Comments on Eversource's Application to Easton for a Conditional Use Permit for damages to wetlands.

Comment for SEC 2024-02,
DE-24-087 and the Easton
Planning Board and ZBA

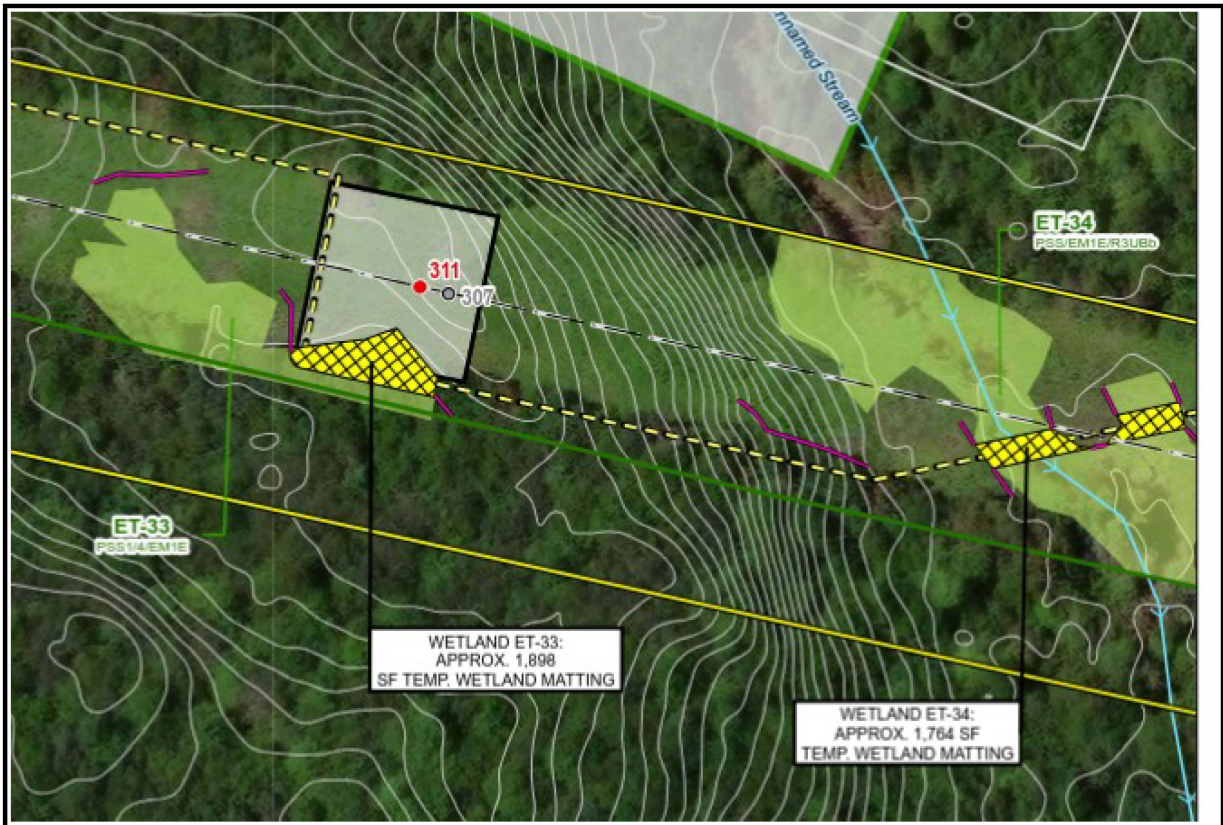
Eversource fails to mention that NHDES Alteration of Terrain Bureau has not approved the AoT or Standard Dredge and Fill Wetlands permits for the X-178 (2) Phase 2 and the Town of Easton and easement-encumbered landowners have not received these permit and permit waiver applications.

Map 9. Delineation of Local Wetland Buffer is missing: As with the Site Plan Review application the map shows a construction “pad” over the woods road and the WMNF overlay is incorrect.

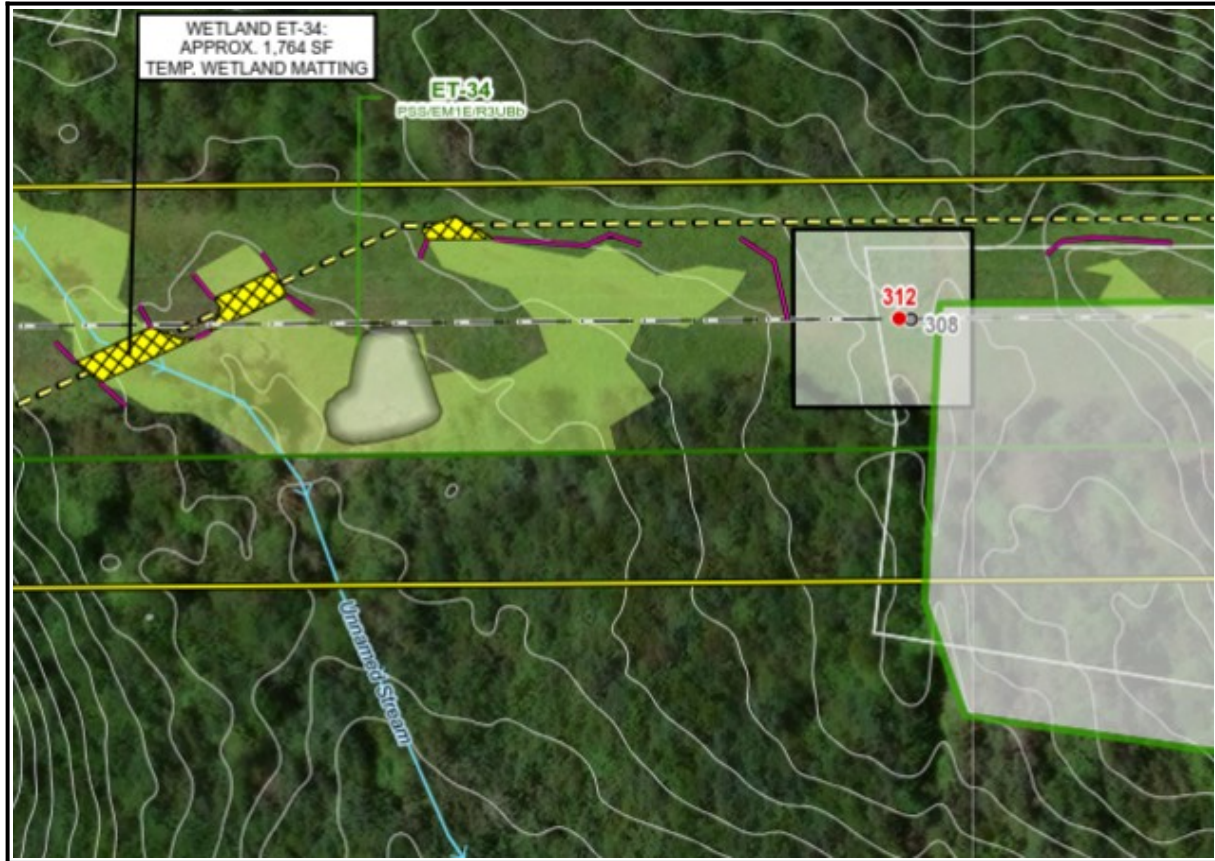
Above: Map 8. Delineation of Local Wetland Buffer is missing.

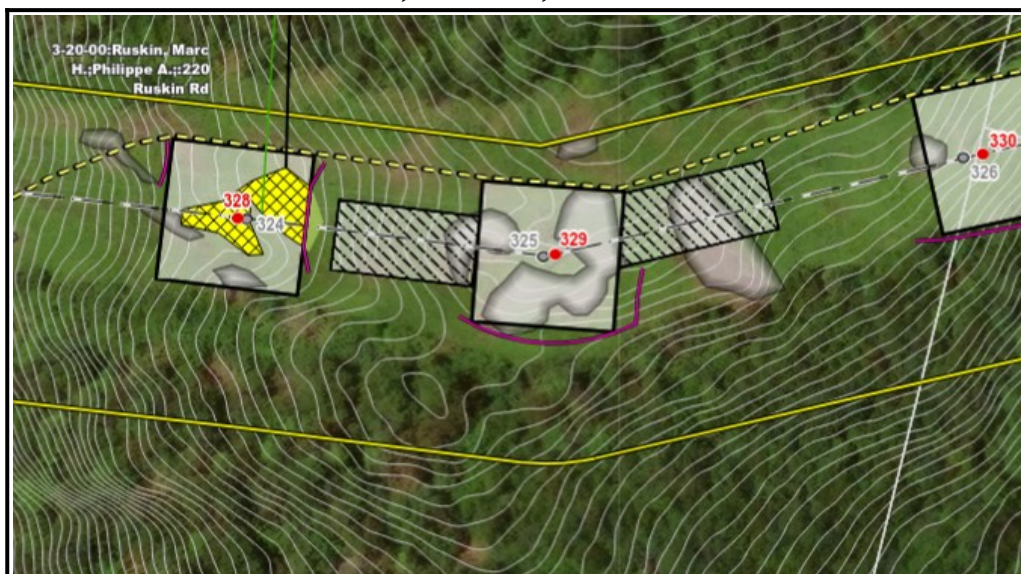
Map 14. This map shows ledge, most especially at the height of land from which there is a beautiful view of Moosilauke, Mt. Blue, Beech Hill and the Kinsmans. This area used to be pasture, likely part of the Samuel Cole Farm. The ledge is a natural feature with cultural and ecological value and I suggest you act in accordance with Easton’s Master Plan and do not destroy it.

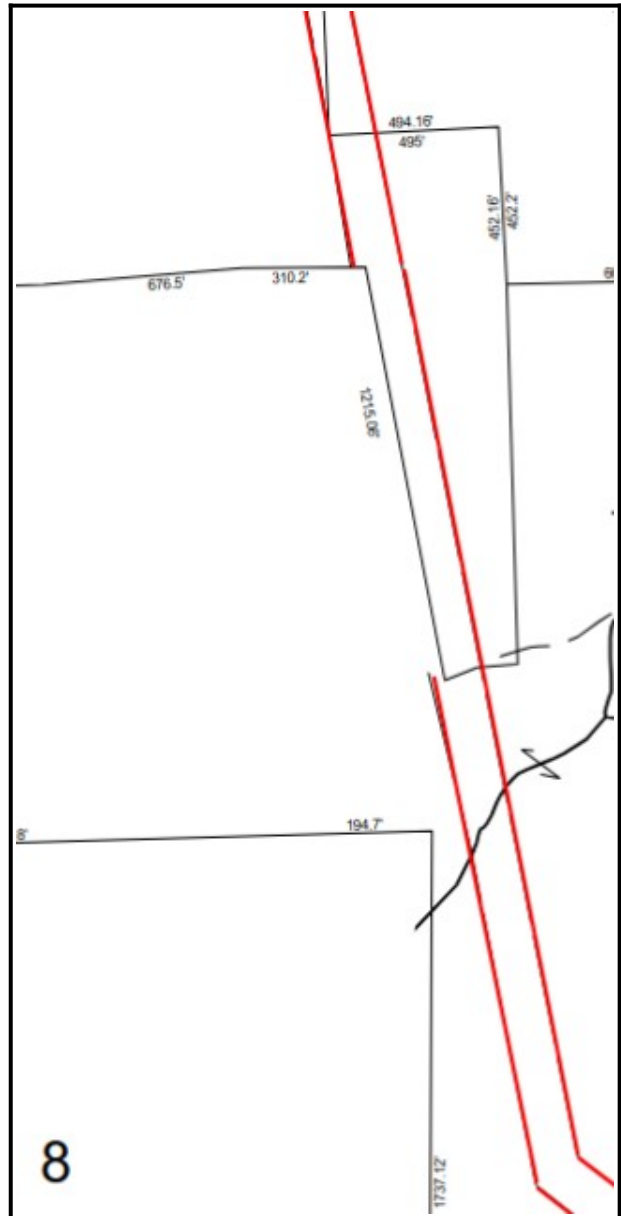
The tax map is outdated and inaccurate. The easement boundary is the property line in the map right:
